ADDENDUM # 4

Solicitation Number: 20-1207

Title: Conference Room Renovations-Building 59, CEF, Ottawa

Date: January 25th, 2021

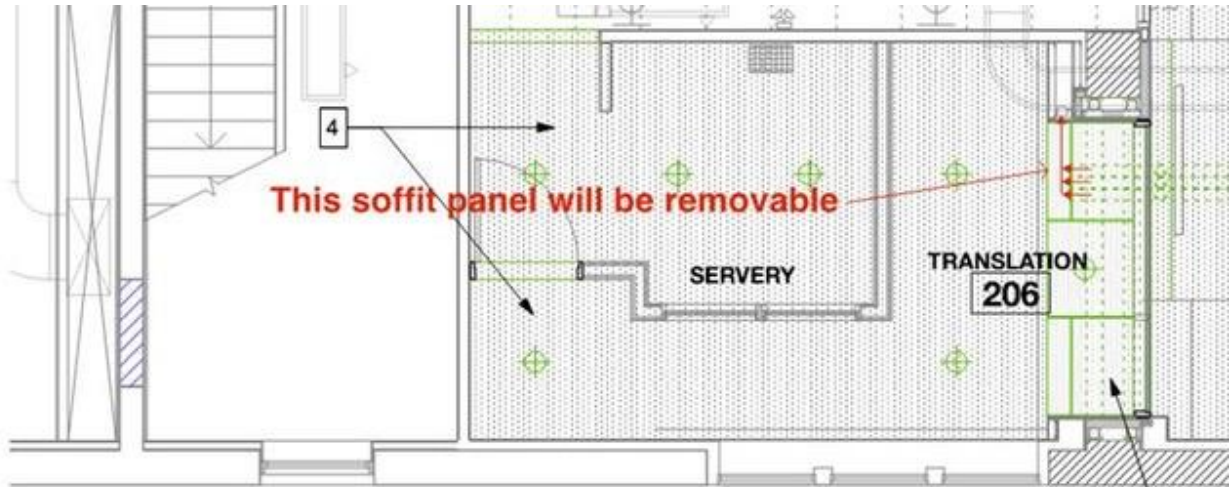
Q 2. Drawing E200, New Layout – Note 10, How many Data Cables are there ? (Is this the Main Data Cabinet for all the floor ?)

A 2. Attached is a photo of the mentioned junction box with cover removed.
